# GORT HISTORIC LANDFILL - H0181-01

## RESPONSE TO REQUEST FOR INFORMATION

Prepared for: Galway County Council

**Date:** November 2022

Drawing No.  
P22-194-0101-0001

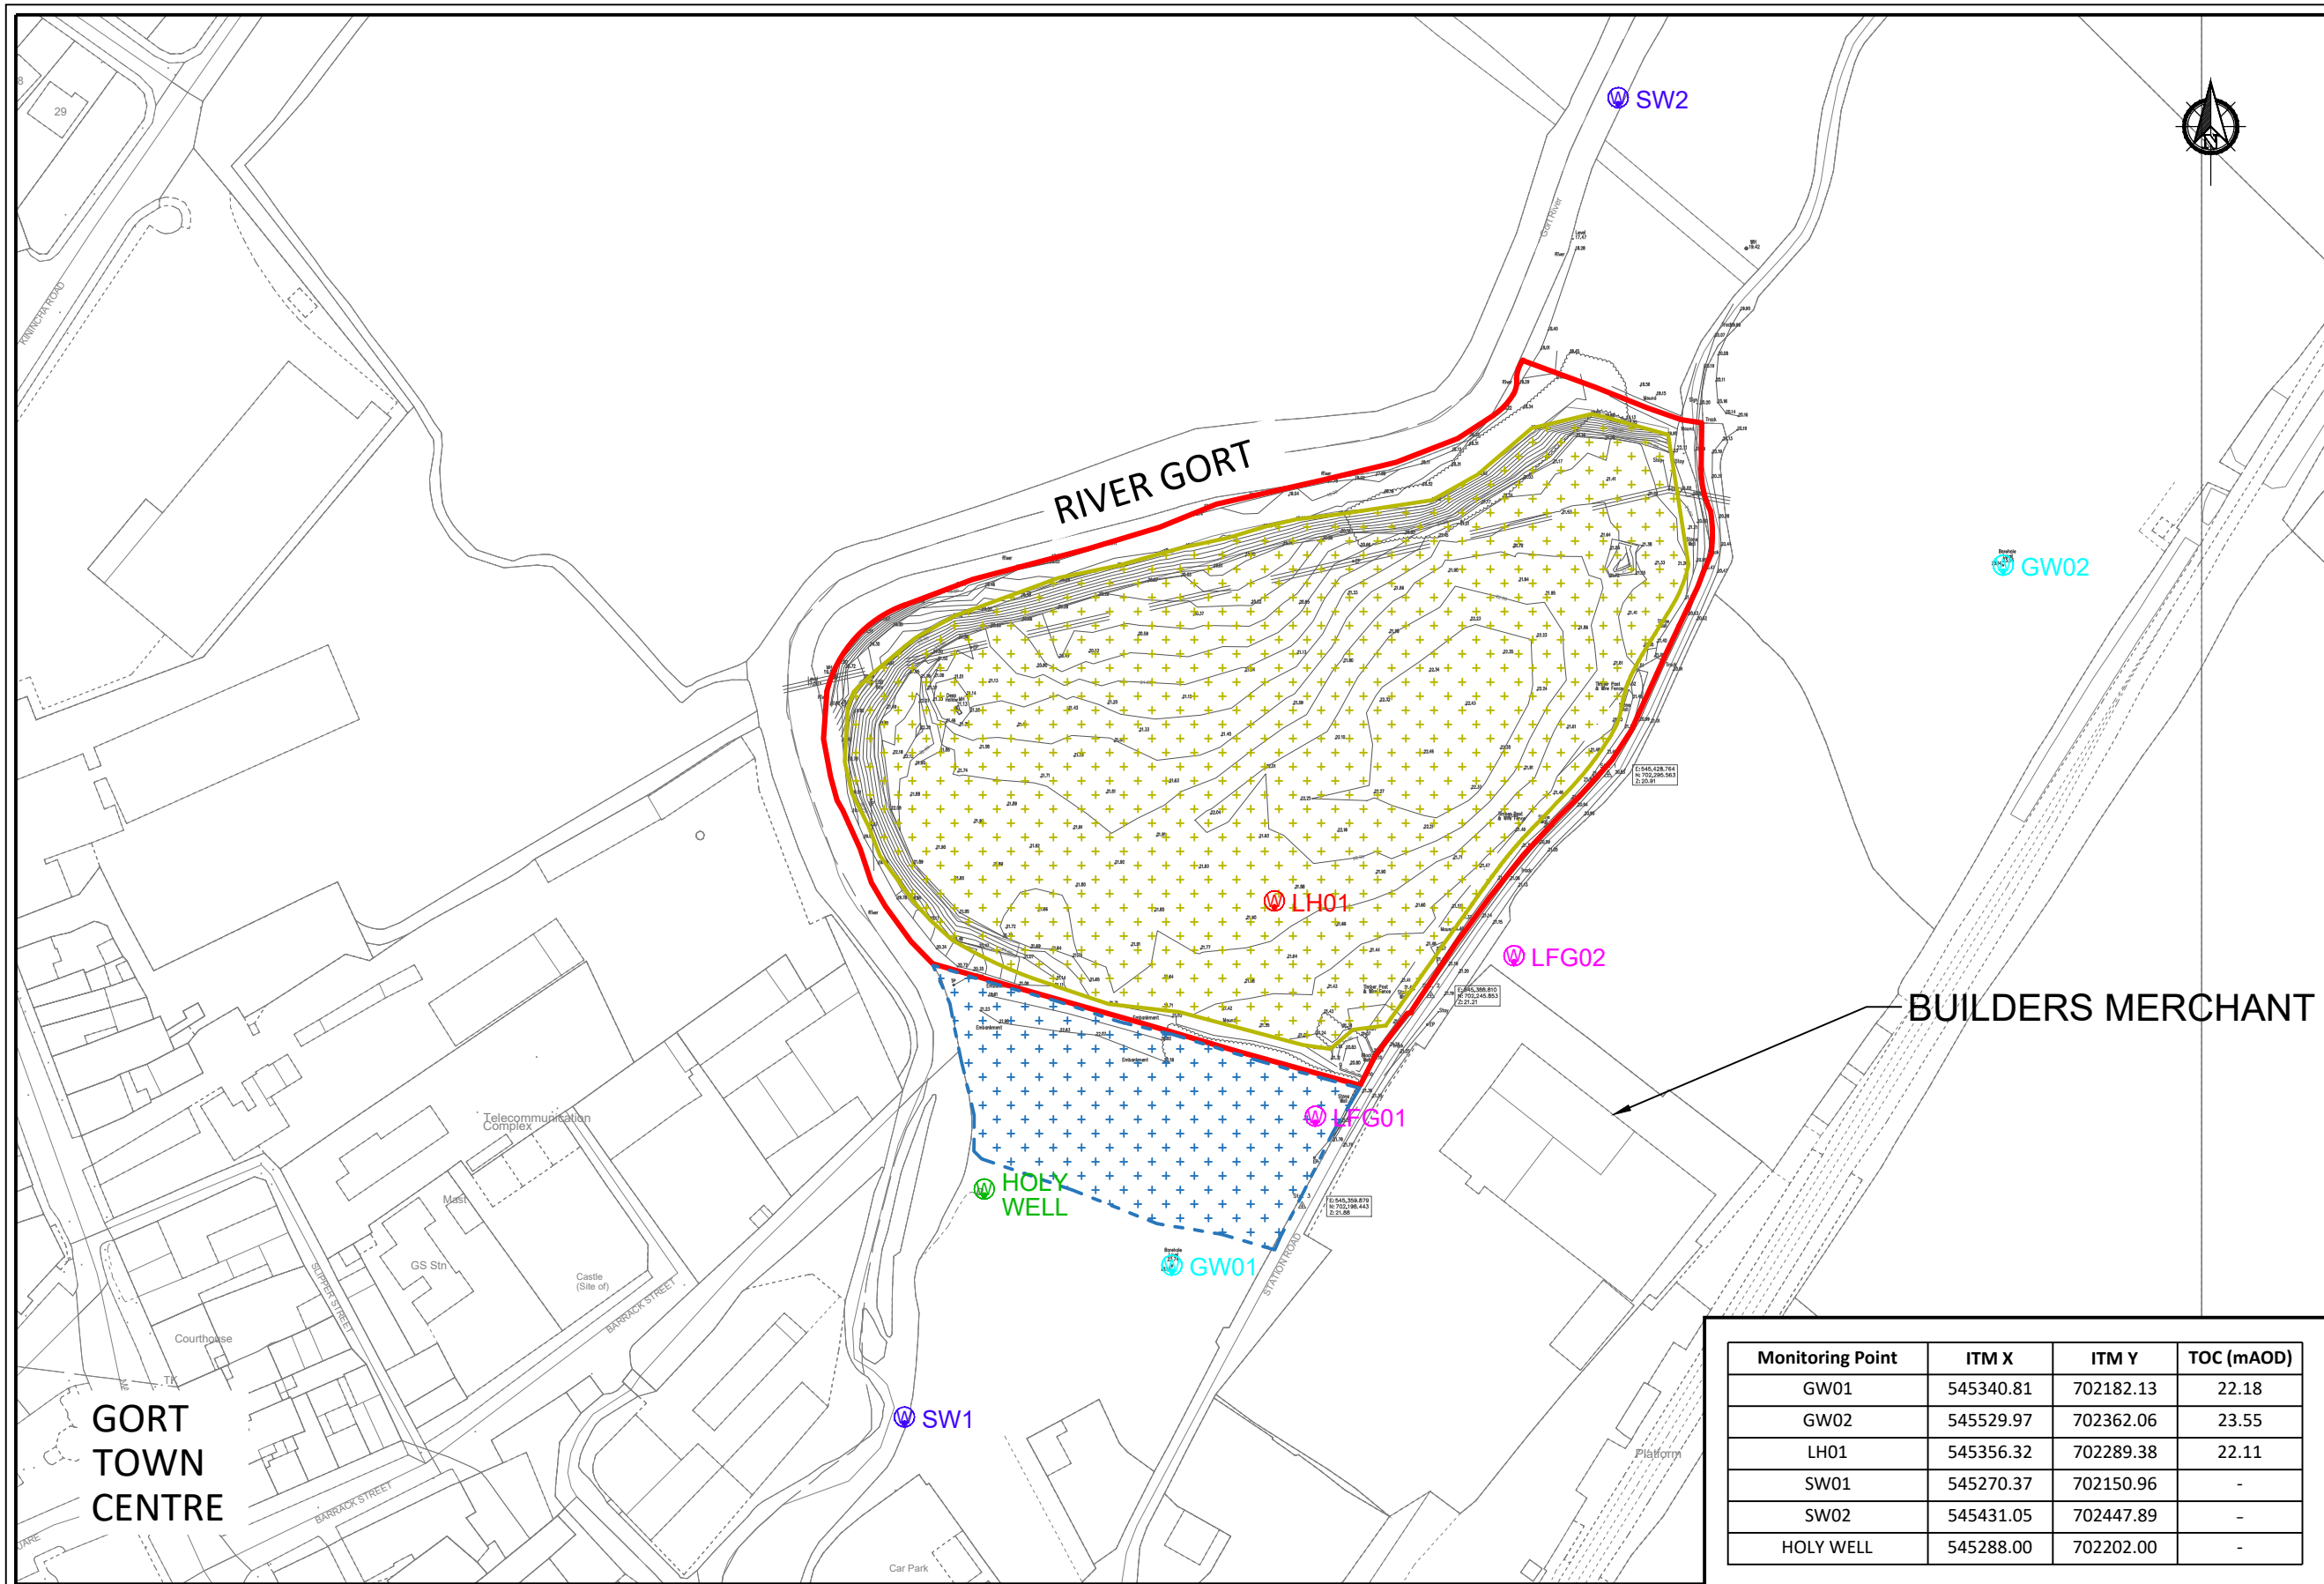
*Provide one Drawing showing all of the following elements interpolated:*

- (i) The entire site boundary in red;*
- (ii) The outline of the waste body boundary, in a different colour than red;*

- (iii) *The area to be capped, in a different colour than required in Points (i) and (ii);*
- (iv) *Monitoring locations for leachate, landfill gas, surface water and groundwater;*
- (v) *The leachate collection infrastructure referred to in Point 5(i), if being utilised in the future;*
- (vi) *The Holy Well referred to in Point 6(ii); and*
- (vii) *The 'stone/construction and demolition waste' area referred to in Point 6(iii).*

The location of the Holy Well is included on the Drawing contained in Appendix 4. A photo of the well is shown in Figure 2.1.

The visible area of deposition is shown on the drawing contained in Appendix 4.

Please see Appendix 4 for Drawing No. P22-194-0101-0001.
